Intel[®] I/O Controller Hub 6 (ICH6) Family

Specification Update

November 2007

Document Number: 301474-025

Figure 5-4. LPC Bridge SERR# Generation

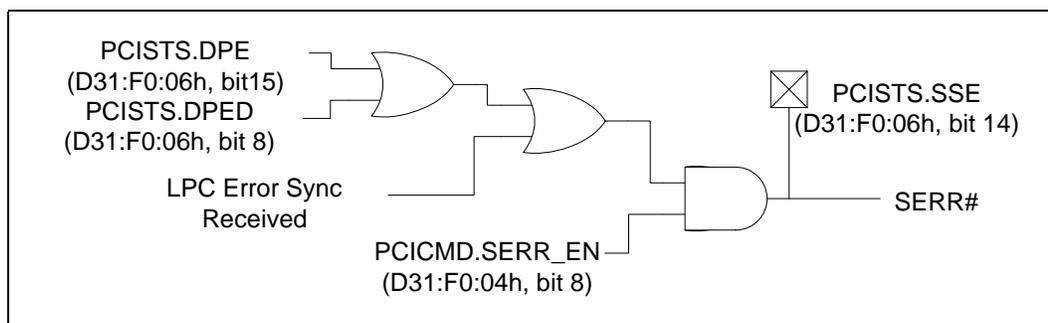
The following is added as section 5.5.2:

The first class of errors is parity errors related to the backbone. The LPC Bridge captures generic data parity errors (errors it finds on the backbone) as well as errors returned on the backbone cycles where the bridge was the master and parity error response is enabled. If either of these two conditions is met, and with SERR# enable (PCICMD.SERR_EN) set, SERR# will be captured.

Additionally, if the LPC Bridge receives an error SYNC on LPC bus, an SERR# will also be generated.
